DOVER PLANNING BOARD – AGENDA

Meeting Type: Regular Meeting
Meeting Location: Council Chambers, City Hall, 288 Central Ave, Dover NH 03820
Meeting Date: **Tuesday, November 12, 2019**
Meeting Time: **7:00 pm**

PLANNING BOARD - STAFF MEMO FILE #P19-73

Application Type: Site Plan
Applicant(s): City of Dover
Owner(s): City of Dover
Location: 145 Court Street (Assessor's Map 18, Lot 1)
Meeting Date: November 12, 2019

**VEHICLE MOVEMENT
PLAN**

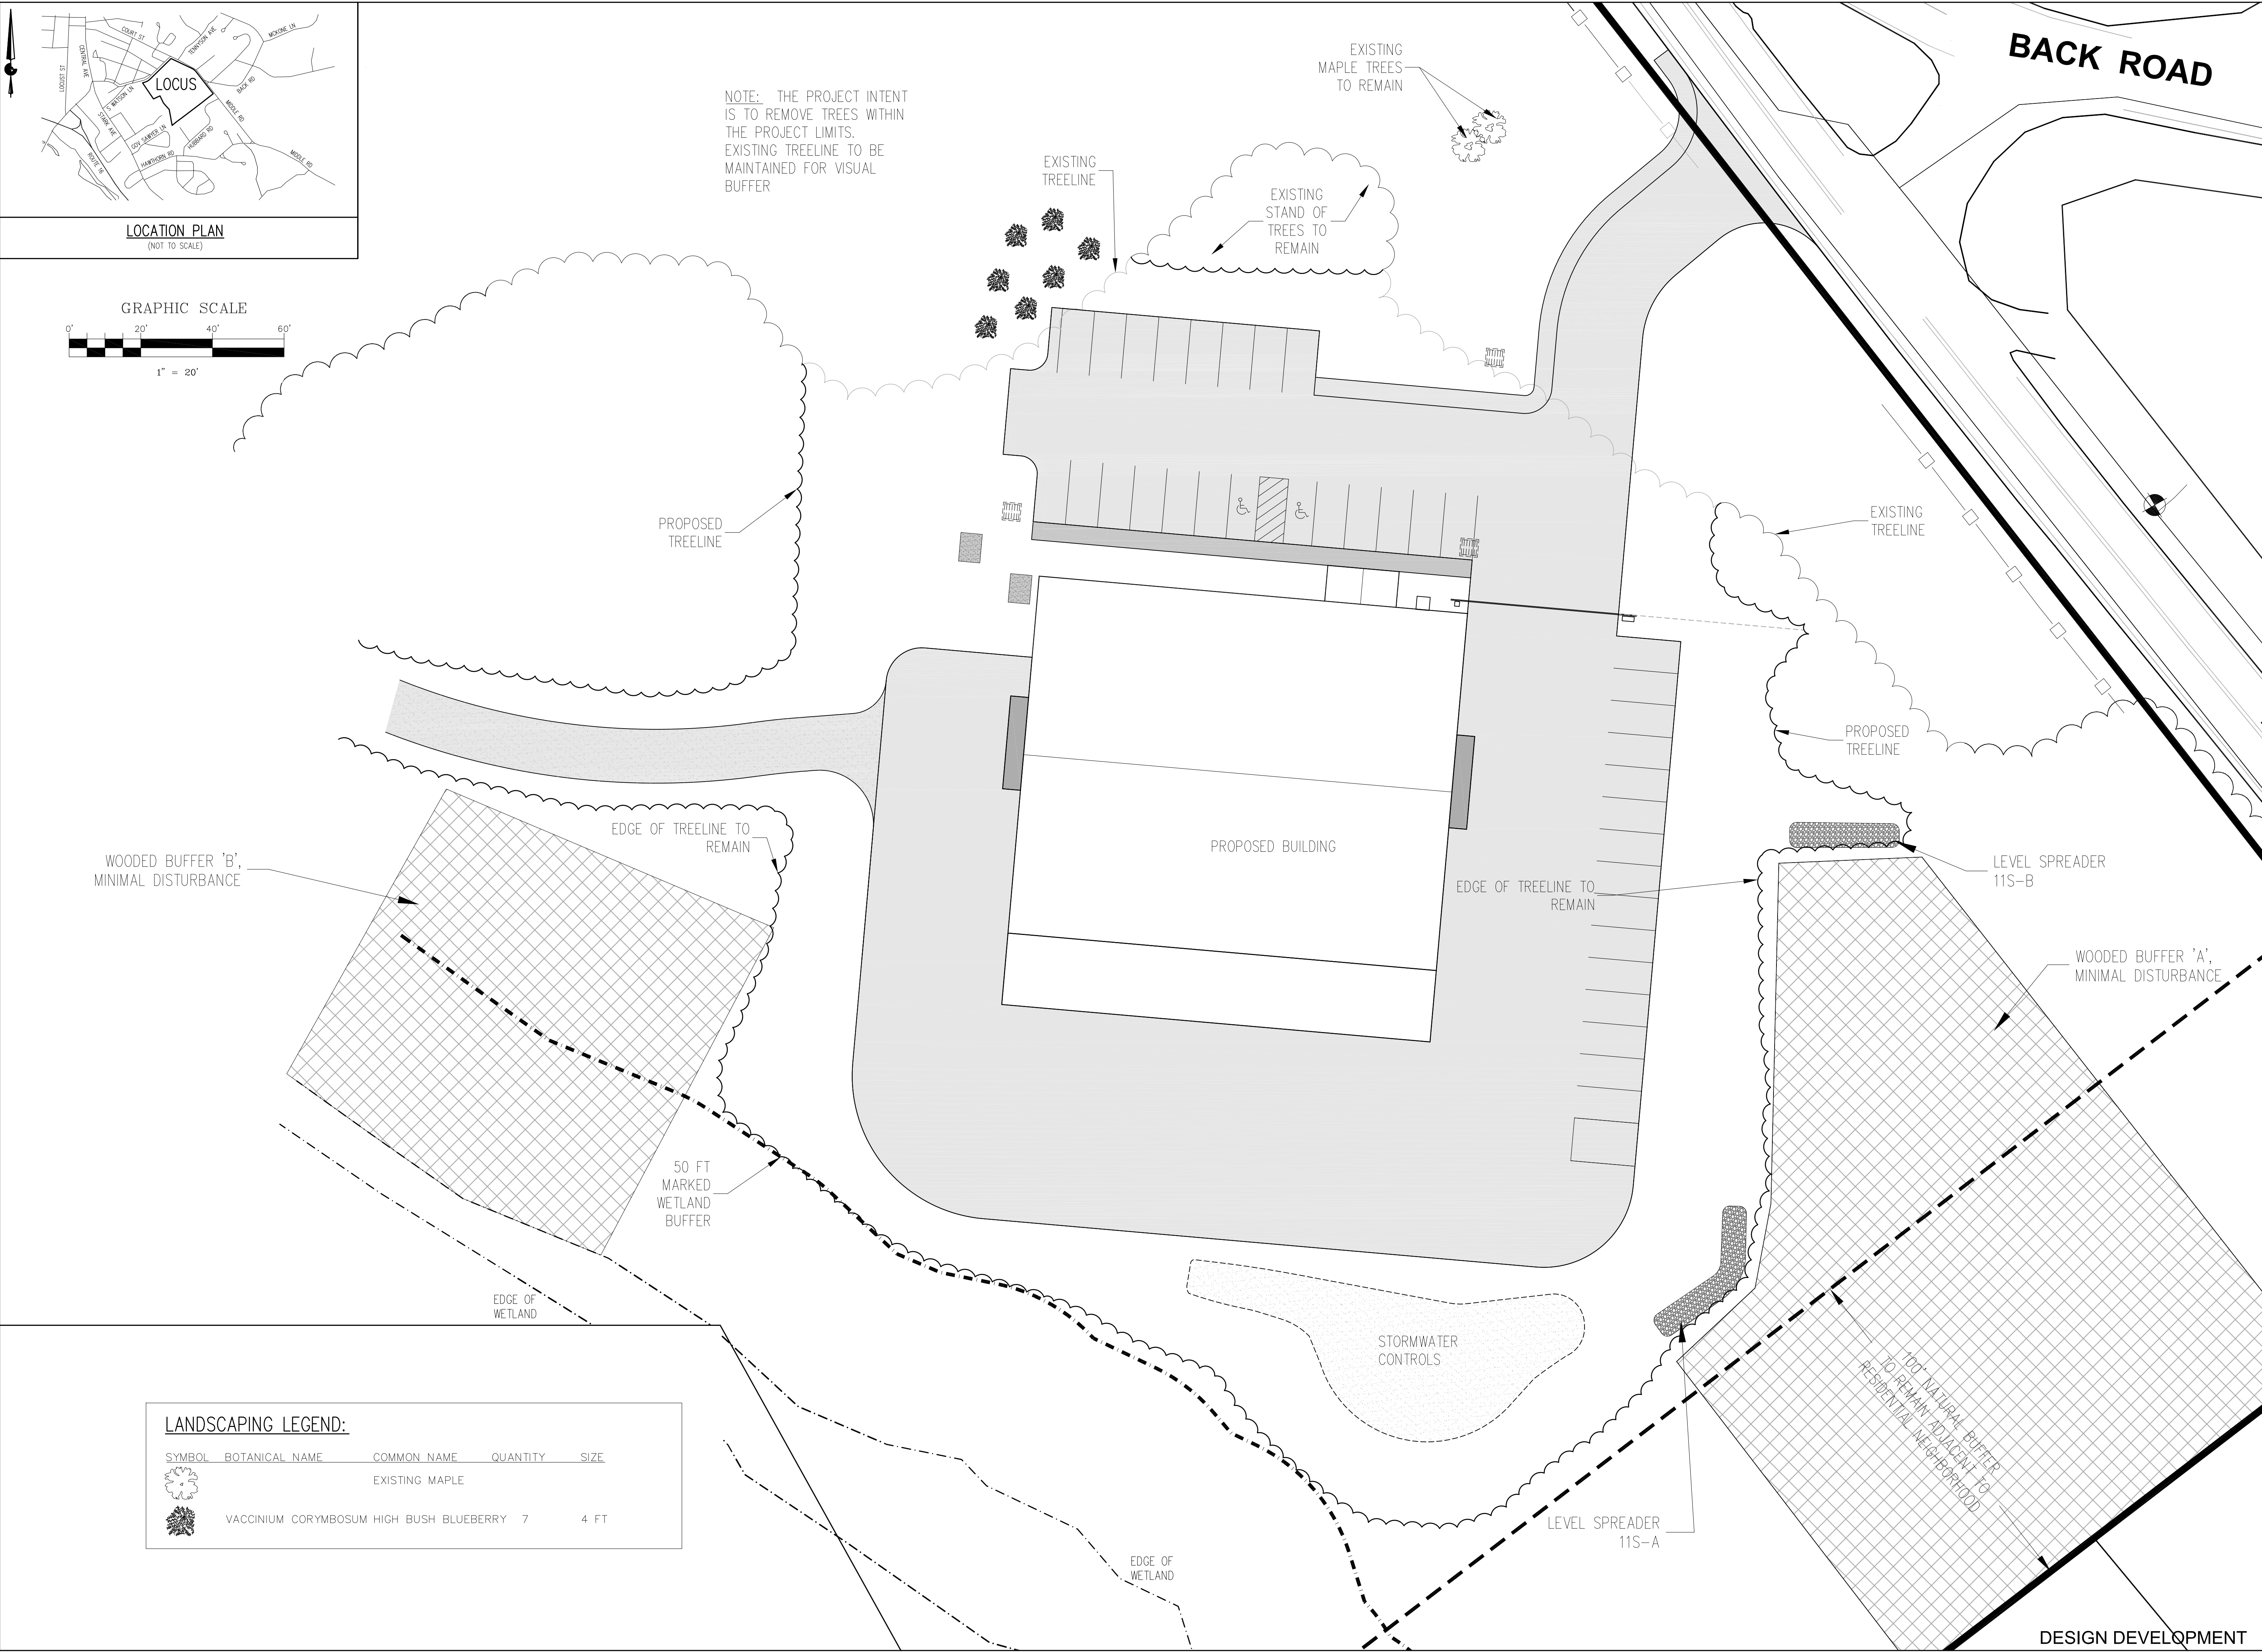
- Provide:
 - Utility plan
 - Turning template for fire apparatus
- Revise Plan to:
 - Locate nearest hydrant
 - Locate FDC on front of building
 - Locate potential location for generator
 - Locate transformer location

EXTERIOR ELEVATIONS

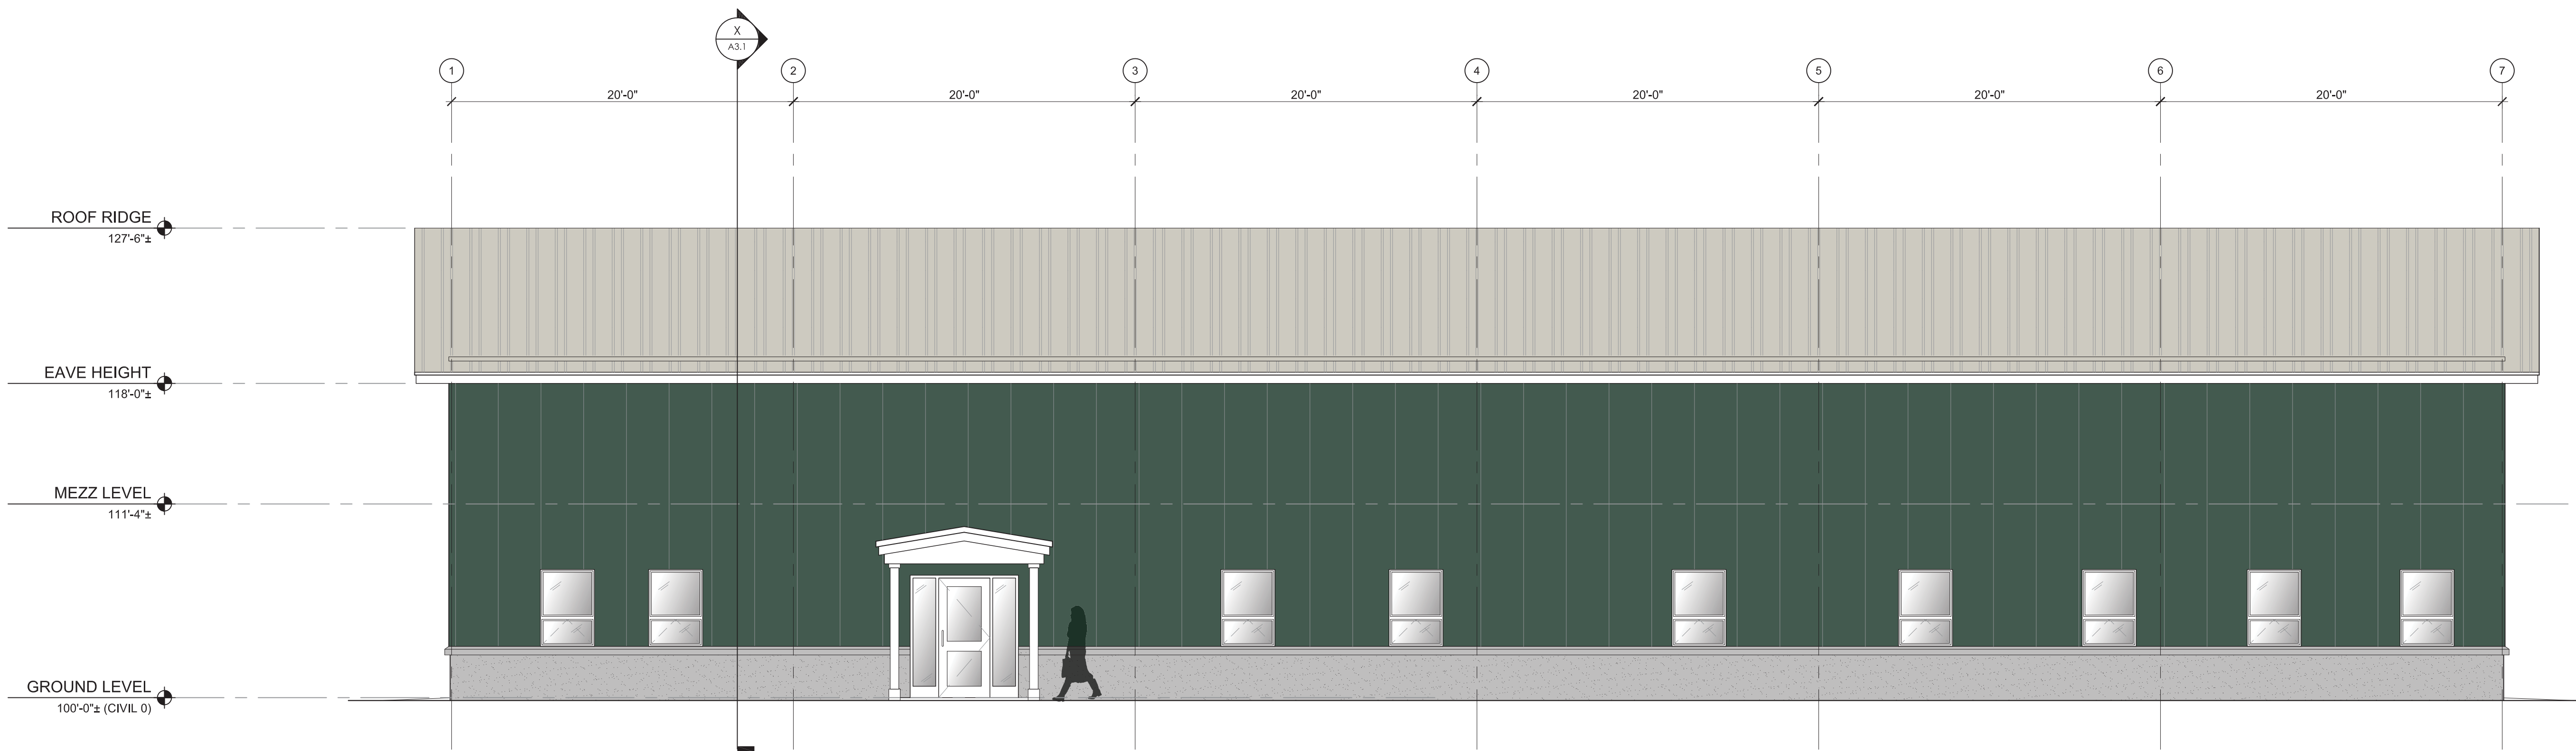
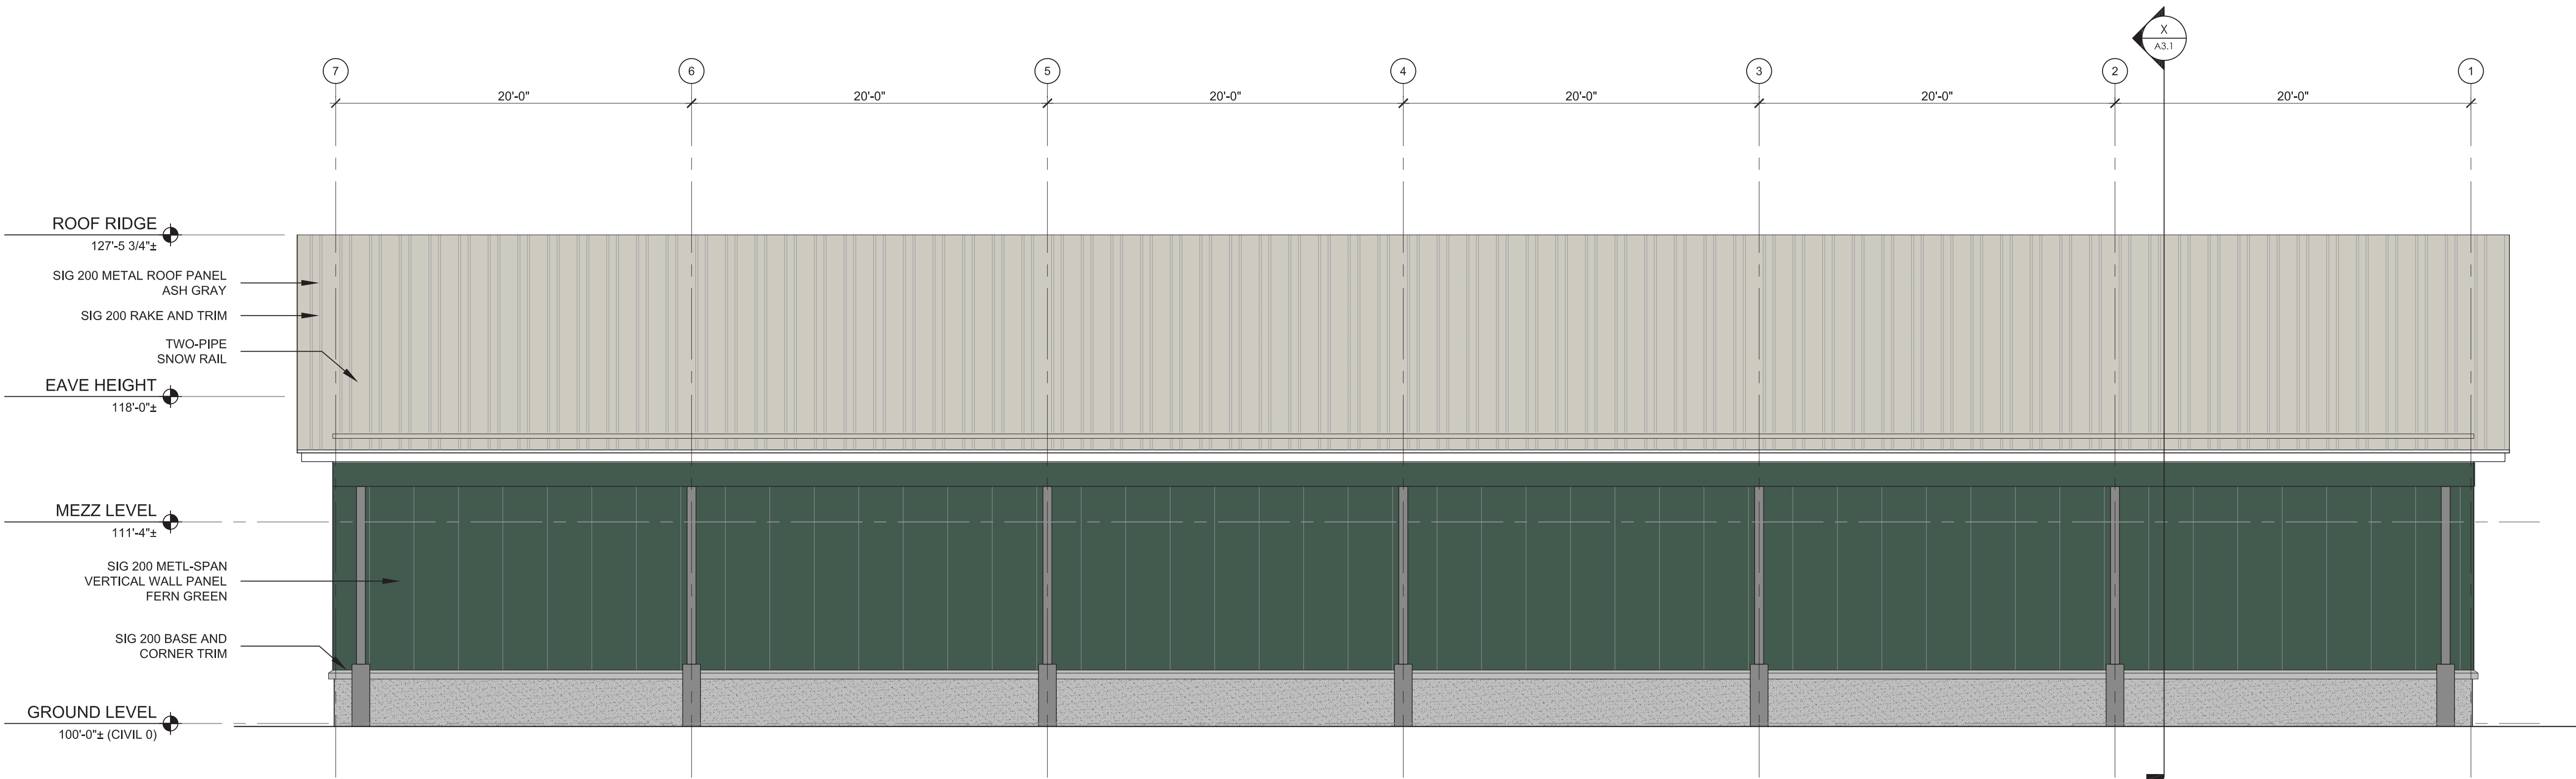
- Update rendering of building to add stucco or other finish to concrete base
